Agenda

Natural Features Protection Review Board

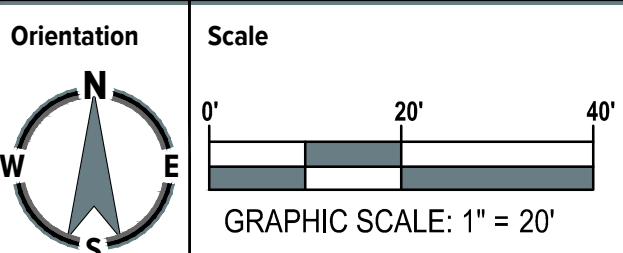
FILE LOCATION: \\sme-hq1\proj\097987\proj\097987.dwg; NFP COMMENTS: NFP COMMENTS
